HISTORIC AND DESIGN REVIEW COMMISSION

HDRC CASE NO: 2020-237
ADDRESS: 1438 W ROSEWOOD AVE
LEGAL DESCRIPTION: NCB 2763 BLK 68 LOT 3
ZONING: R-4, H
CITY COUNCIL DIST.: 1
DISTRICT: Keystone Park Historic District
APPLICANT: Erasmo Castillo/Castillo's Complete Construction
OWNER: AEBB PROPERTIES LLC
TYPE OF WORK: Rear addition, enclosure, porch
APPLICATION RECEIVED: June 26, 2020
60-DAY REVIEW: Not applicable due to City Council Emergency Orders
CASE MANAGER: Huy Pham

The applicant is requesting a Certificate of Appropriateness for approval to:

1438 W Rosewood

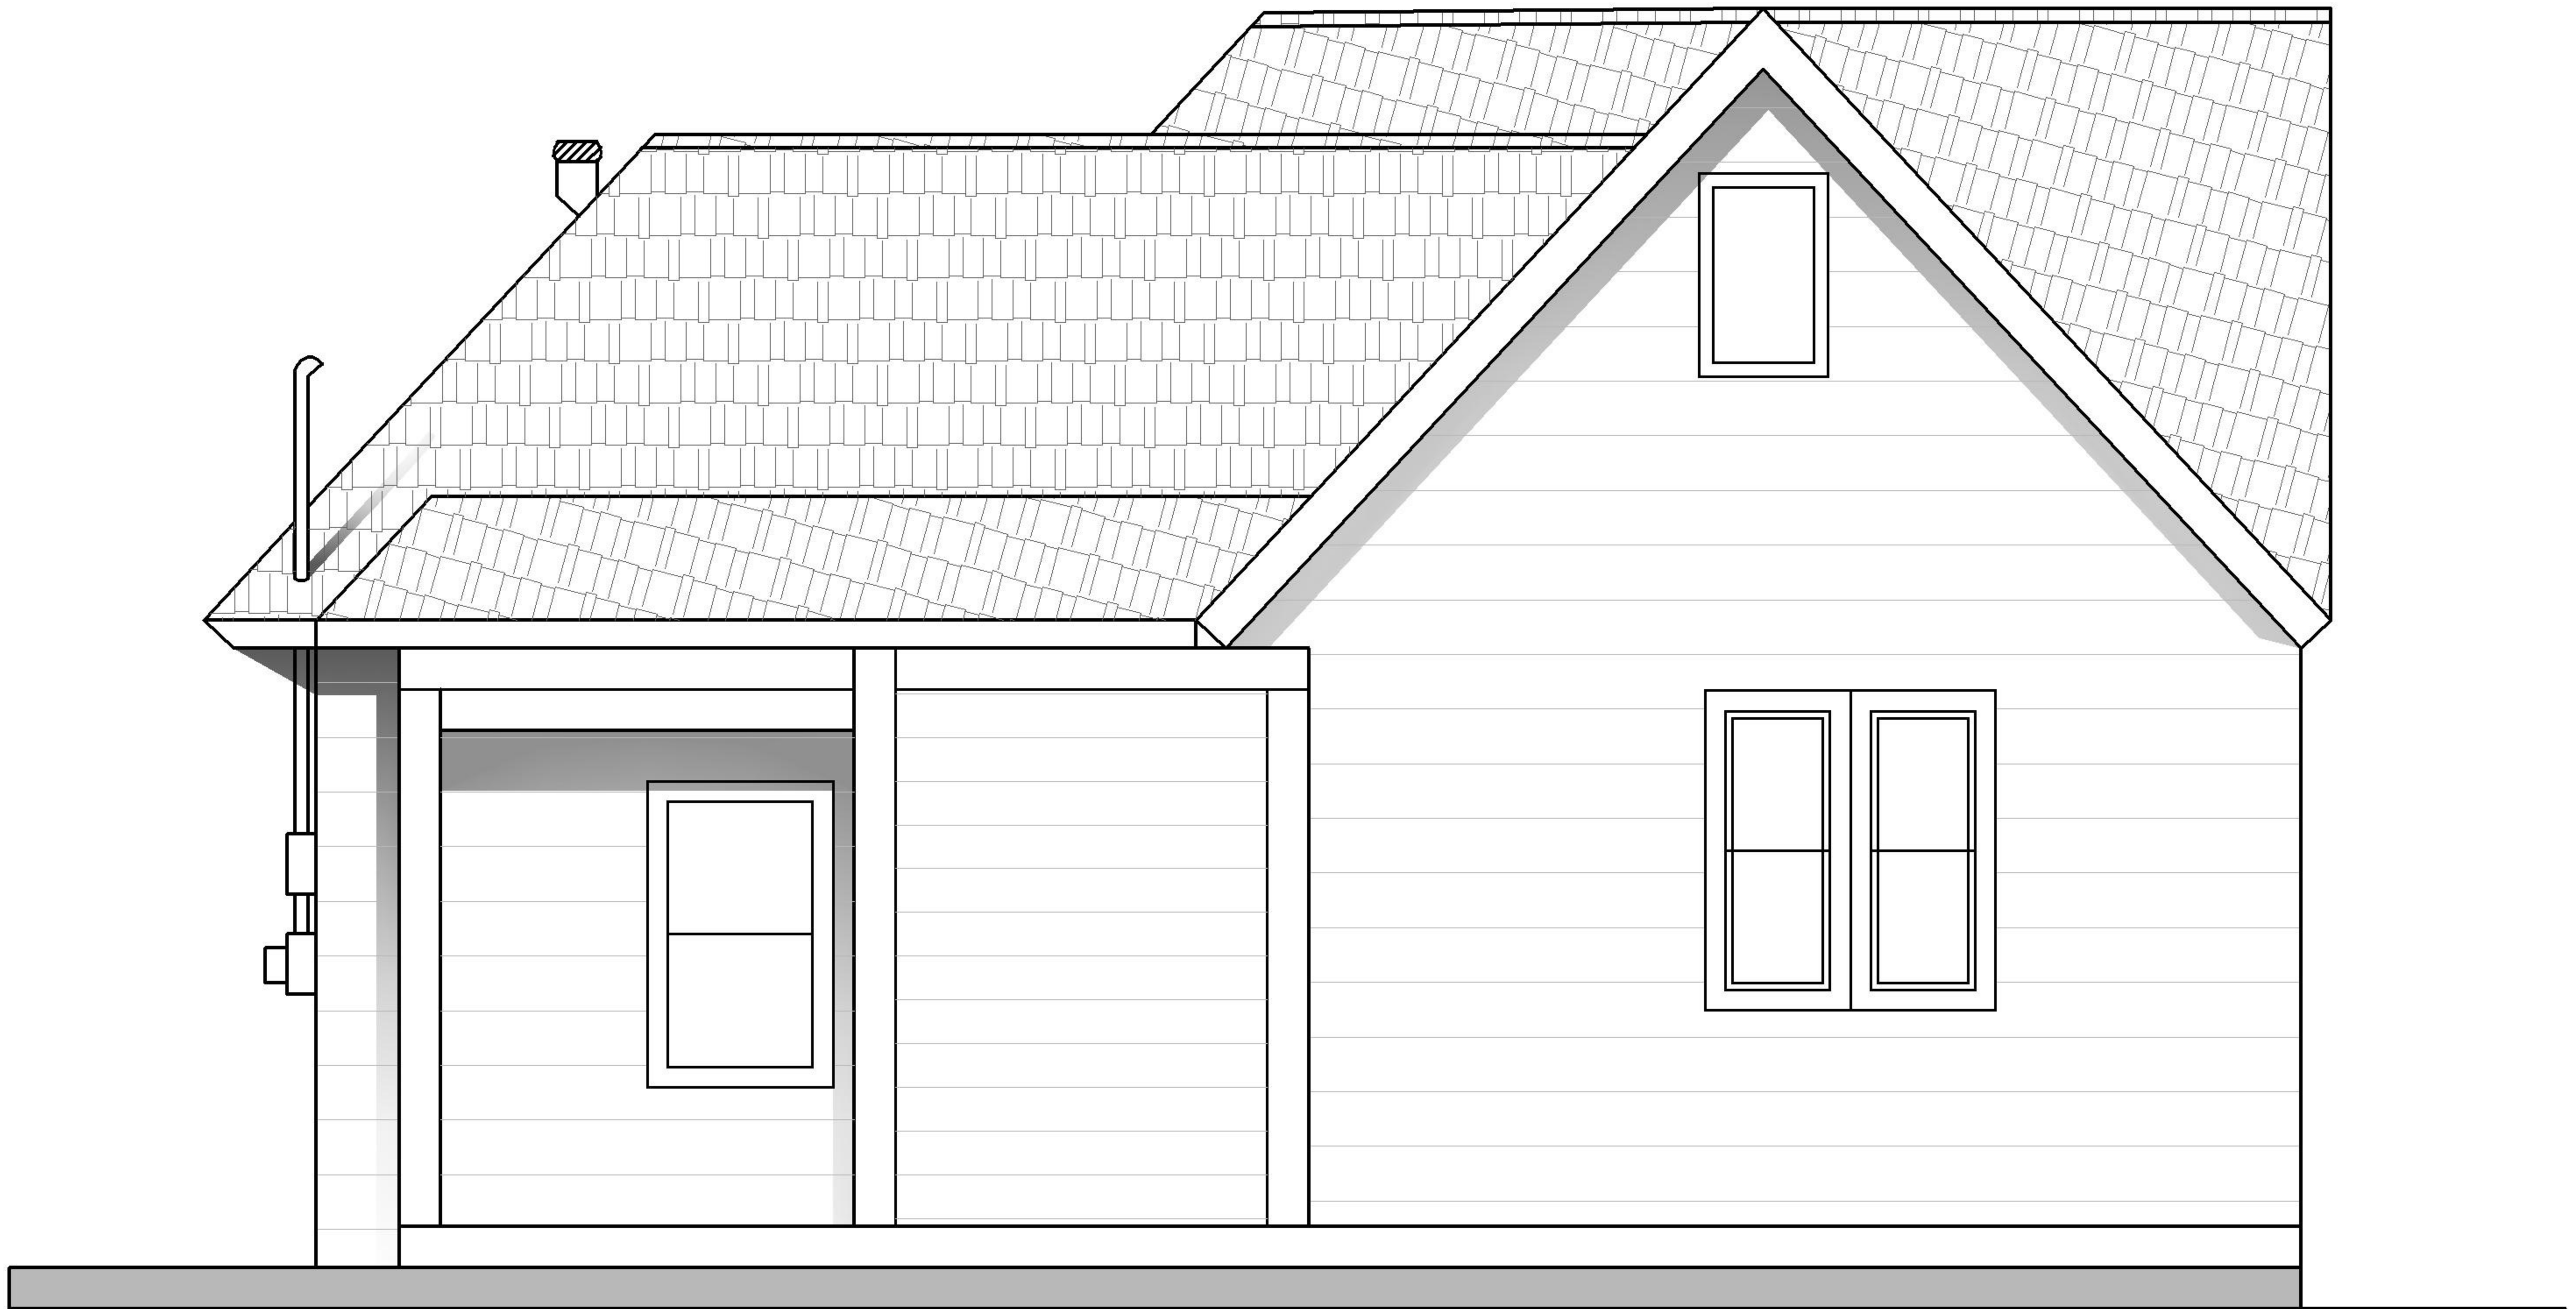
- c. EAST REAR ADDITION – The applicant has proposed to construct a rear addition on the rear of the east elevation featuring a 6’-6” deep by 8’ wide enclosed room with a 6’ deep rear-facing covered porch. The proposed addition features the reuse of existing windows, wood lap siding with a 6’ exposure, and a subordinate shed roof with vertical trim pieces between old and new wall planes. Staff finds the addition generally consistent with the Guidelines for Additions.

- d. WEST REAR ADDITION – The applicant has proposed to construct a rear addition on the rear of the west elevation to square off the inset corner of the existing building footprint. The proposed addition features approximately 5’ in depth and width, wood lap siding with a 6” exposure, a subordinate shed roof, and vertical trim pieces between old and new wall planes. Staff finds the addition generally consistent with the Guidelines

Staff recommends approval of item 1 and 2, the rear additions based on findings c and d with the stipulation that any historic wood windows should be reused or kept on site and that new windows products if used should be verified with staff prior to installation; no new window products are approved at this time.
